FINAL DRAINAGE REPORT

SPACE VILLAGE FILING NO. 4  
EL PASO COUNTY, COLORADO

PCD FILE NO. MS-22-007

SEPTEMBER, 2022

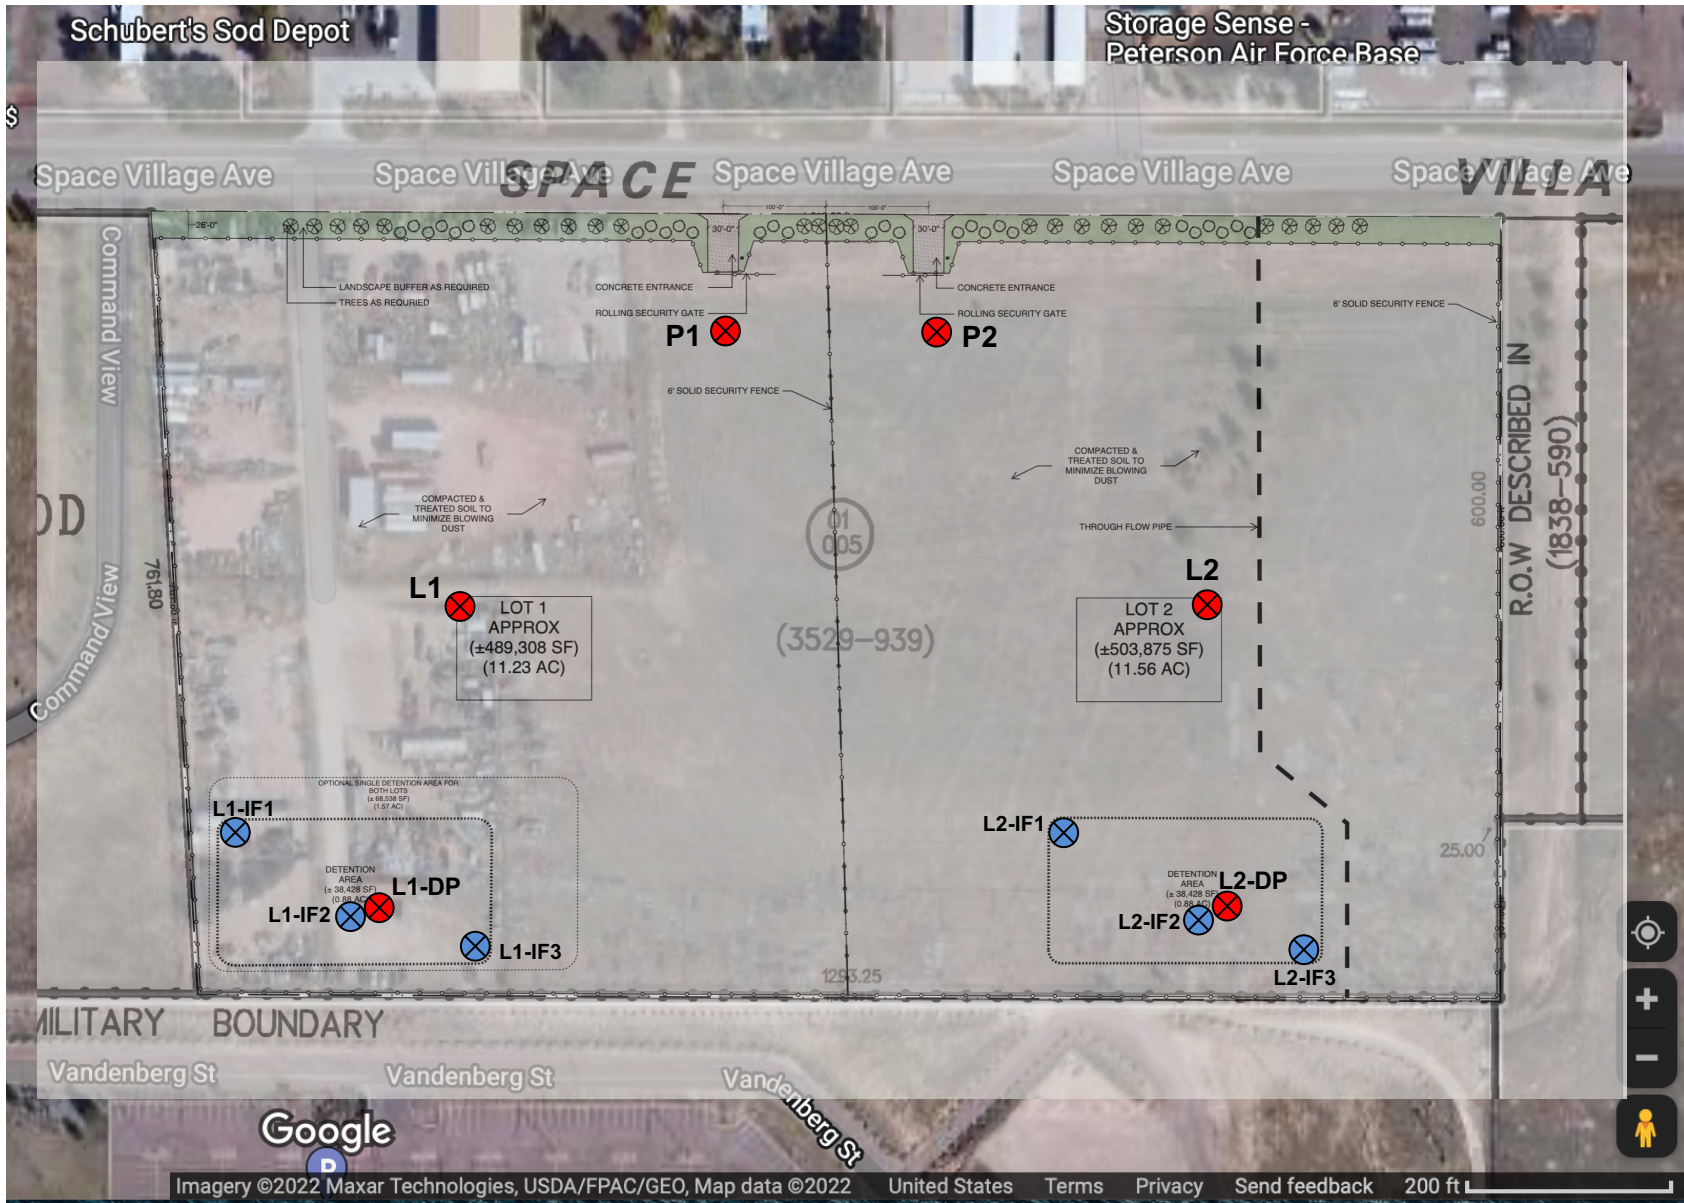
provide the stages and area of the proposed ponds

Provided on sheet 59 below. Revised.

#### SHEET TITLE: FINAL DRAINAGE PLAN (PROPOSED)

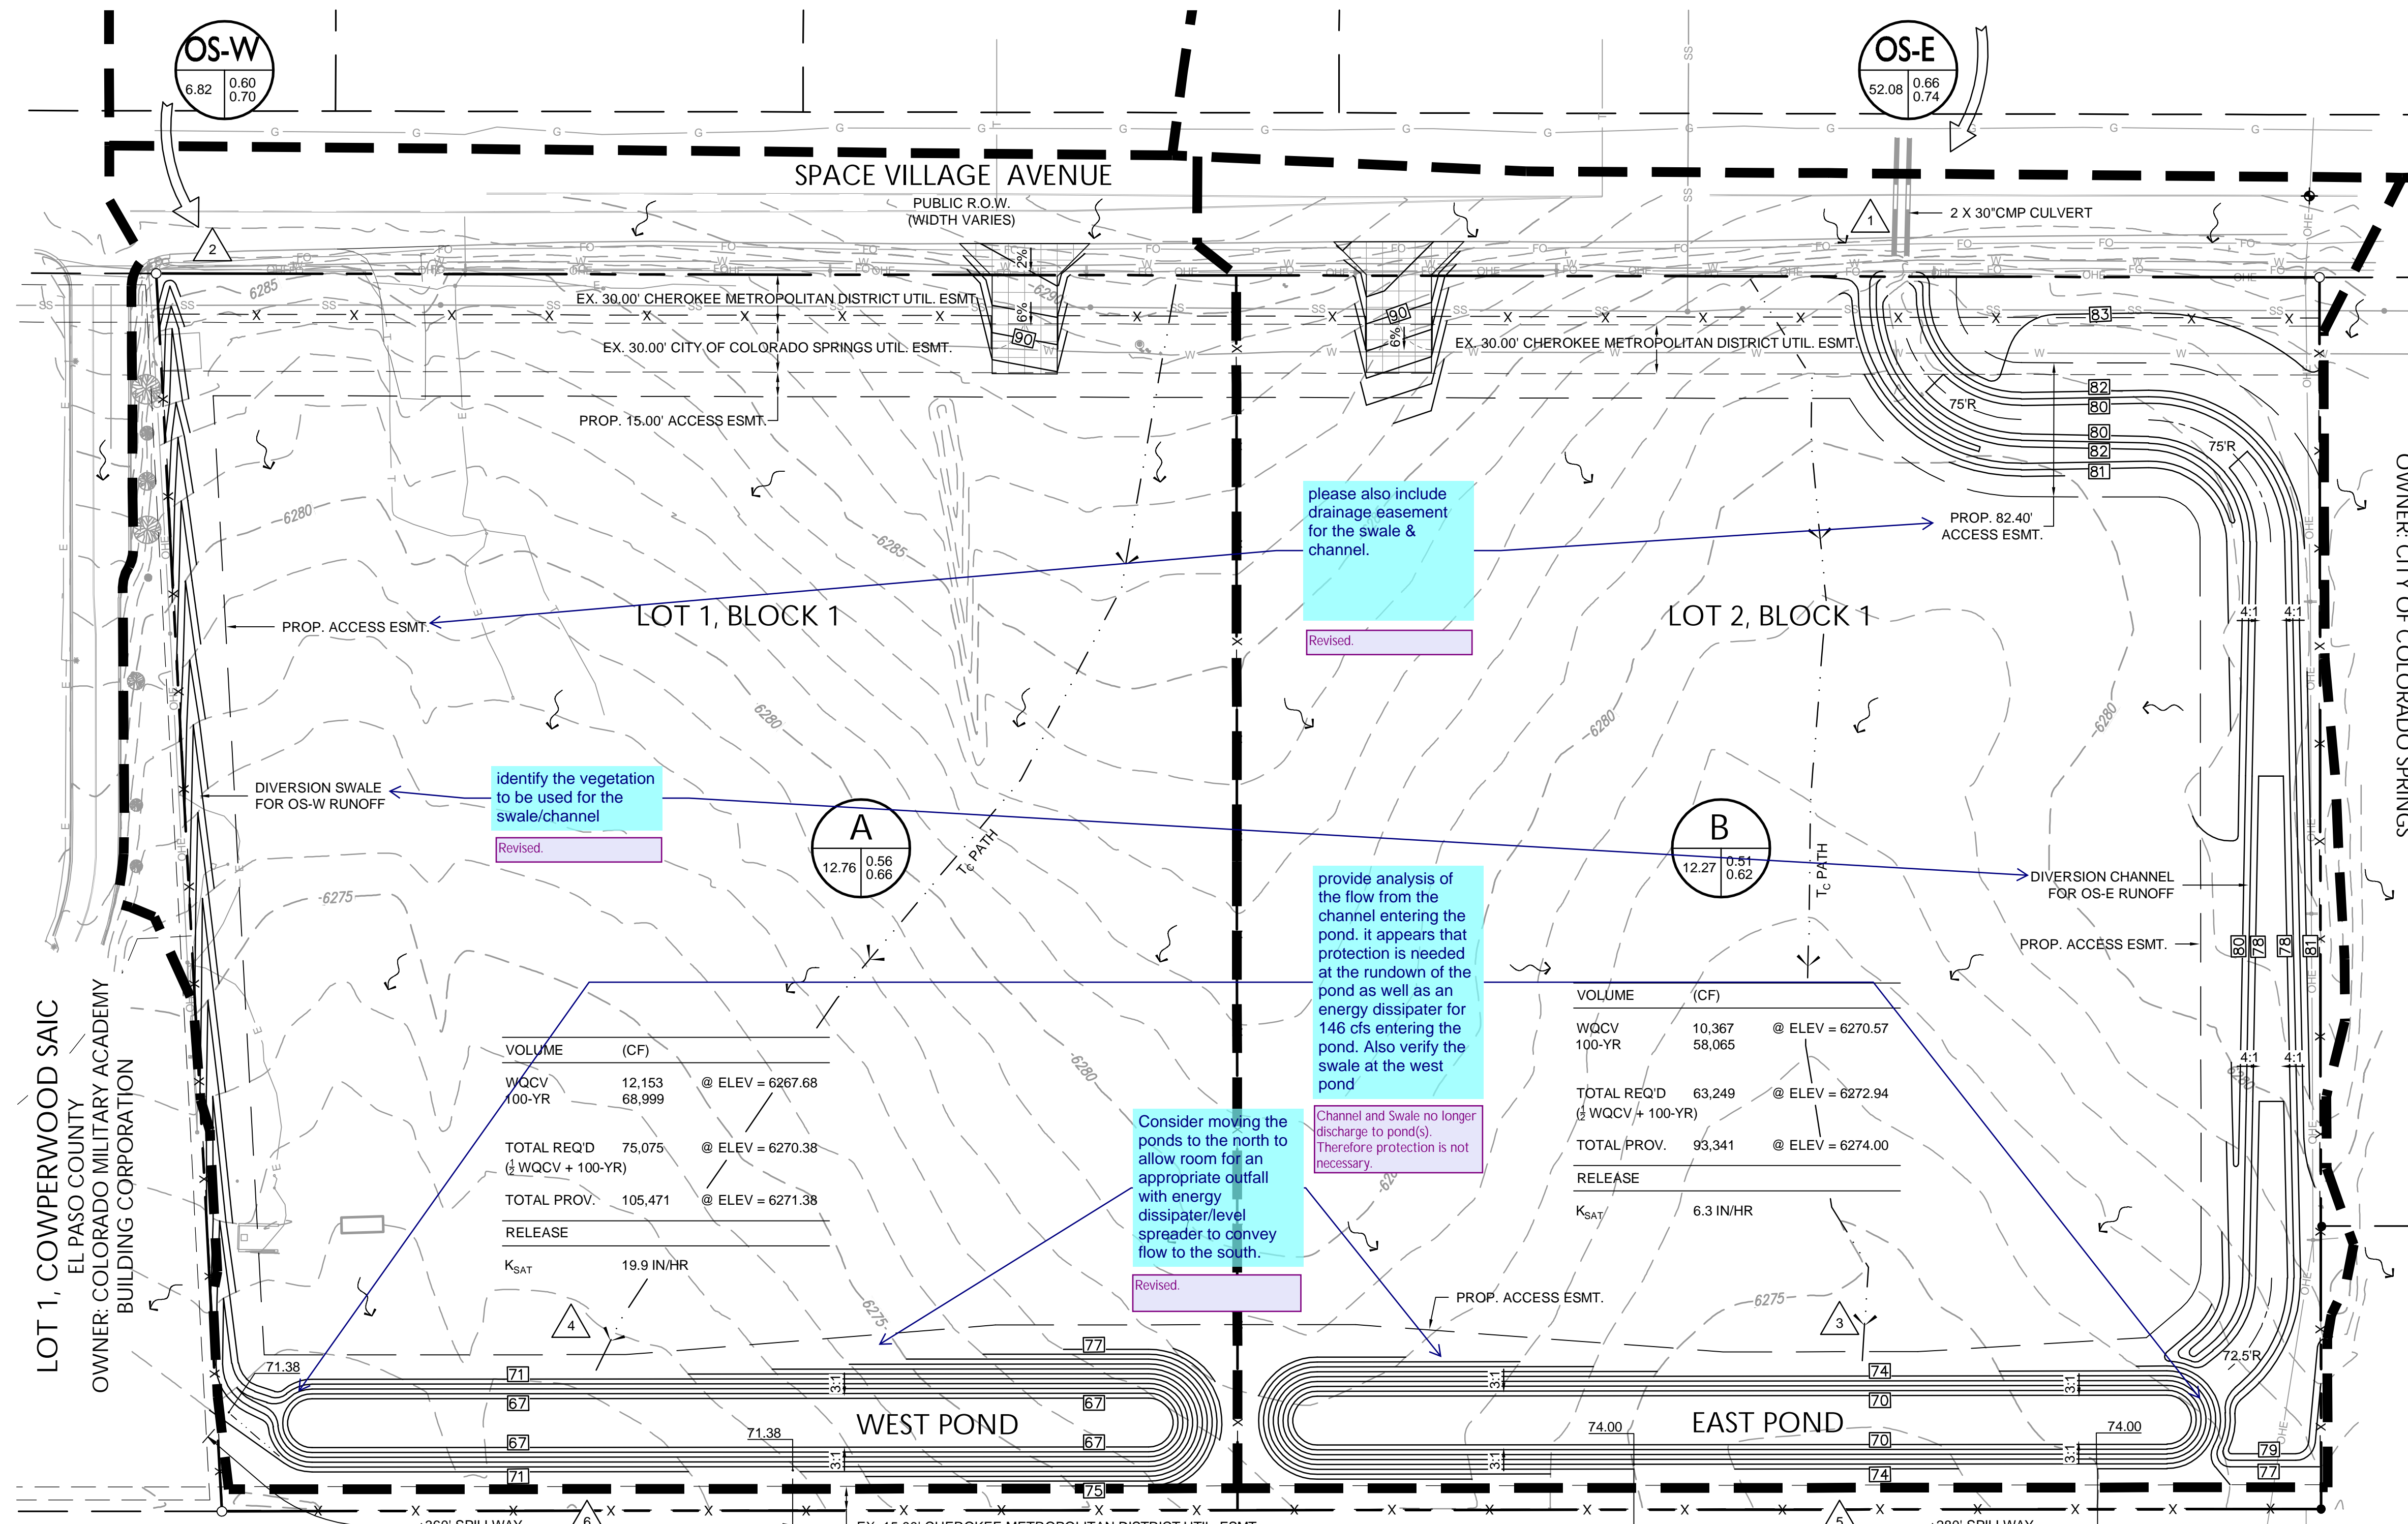
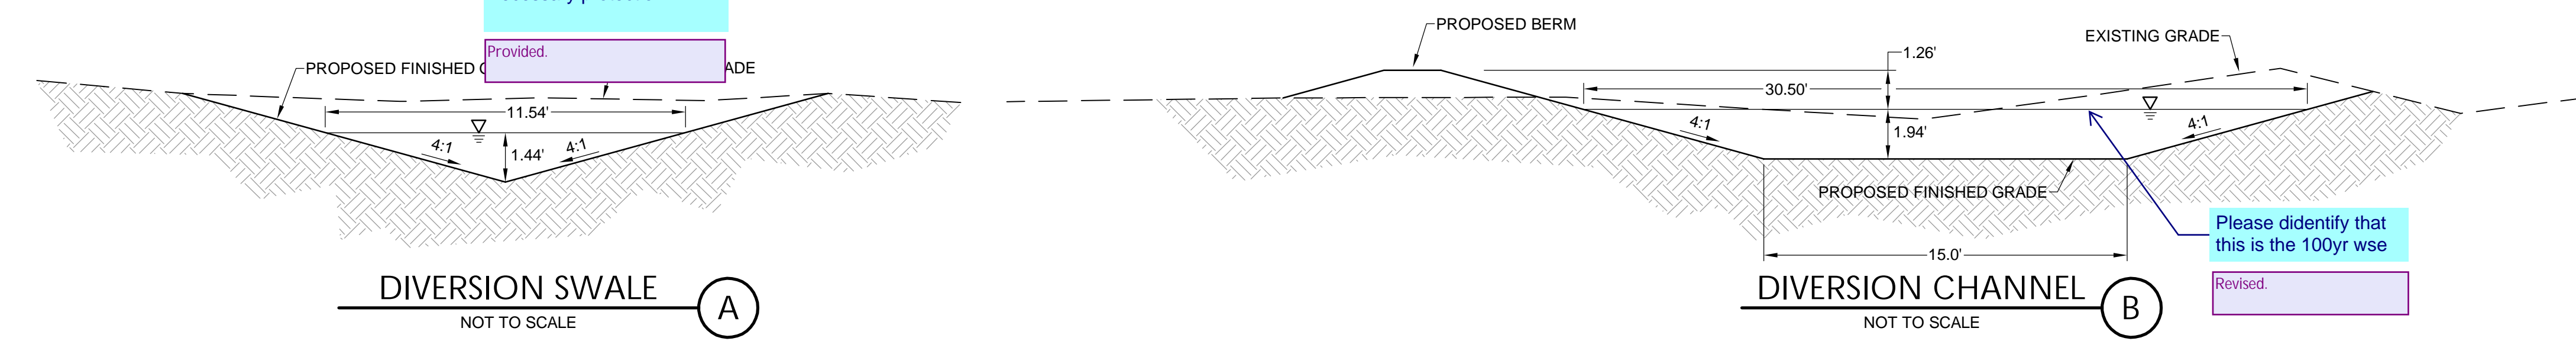
provide analysis of the spillway and identify the necessary protection  
**Provided**

please also include drainage easement for the swale & channel.  
**Revised**

provide analysis of the flow from the channel entering the pond. it appears that protection is needed at the rundown of the pond as well as an energy dissipater for 146 cfs entering the pond. Also verify the swale at the west pond  
**Channel and Swale no longer discharge to pond(s). Therefore protection is not necessary.**

Consider moving the ponds to the north to allow room for an appropriate outfall with energy dissipater/level spreader to convey flow to the south.  
**Revised**

Please identify that this is the 100yr use  
**Revised**
